Integrated Development Application
s100B – Subdivision – Torrens Title Subdivision
195 Fairway Dr Wilton NSW 2571, 8//DP1280088

**STAGES 2 AND 3 SUBDIVISION PROPOSAL
195 FAIRWAY DRIVE, NORTH WILTON**

RE: Development Application DA/2022/1279/1 at 195A Fairway Drive, Wilton

PROPOSED Staged residential subdivision consisting of 318 residential lots, 4 superlots, 6 residue lots and associated works - 195A Fairway Drive WILTON, 195C Fairway Drive WILTON, Lot: 1 DP: 1280088, Lot: 3 DP: 1280088

Site Plan from Endeavour Energy's G/Net Master Facility Model

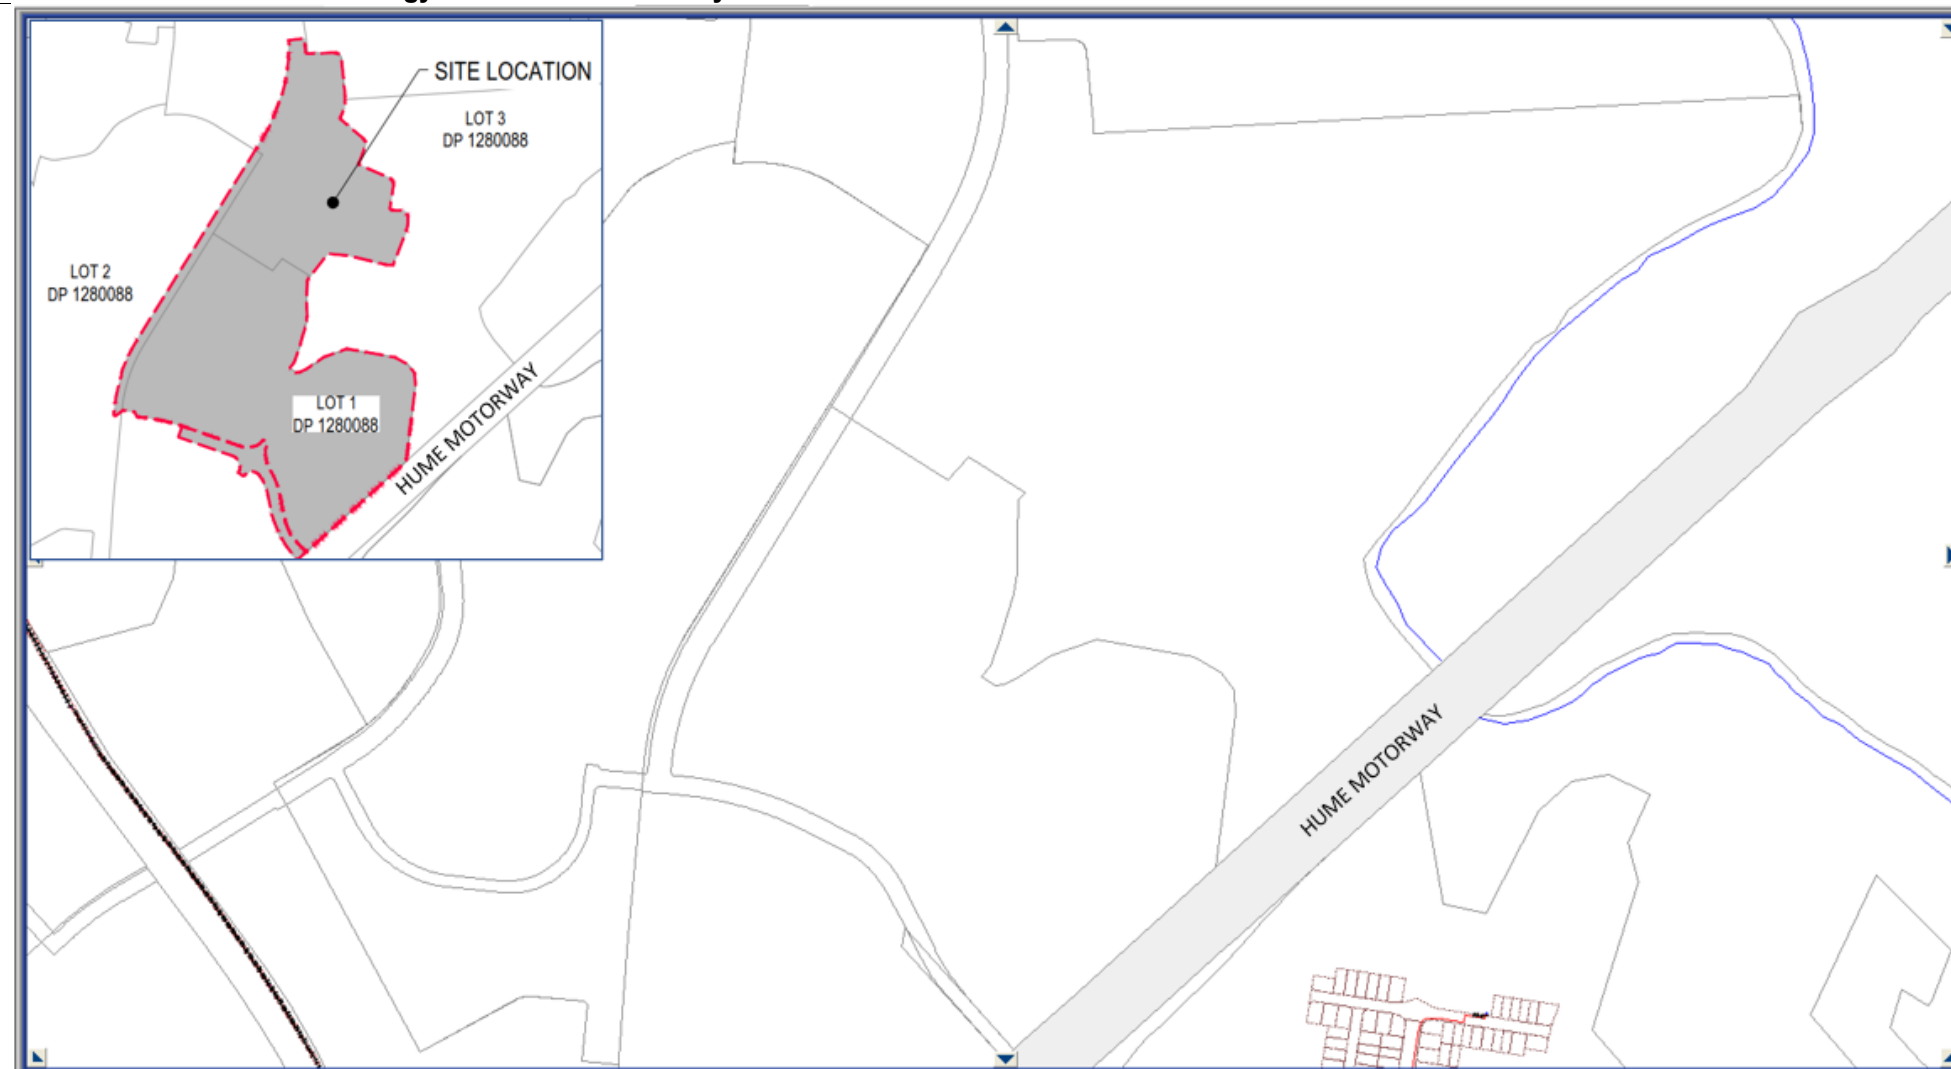
As shown in the below site plan from Endeavour Energy's G/Net master facility model:

In regard to the Site Location there are:

- No easements benefitting Endeavour Energy (active easements are indicated by red hatching).
- No existing electricity infrastructure.
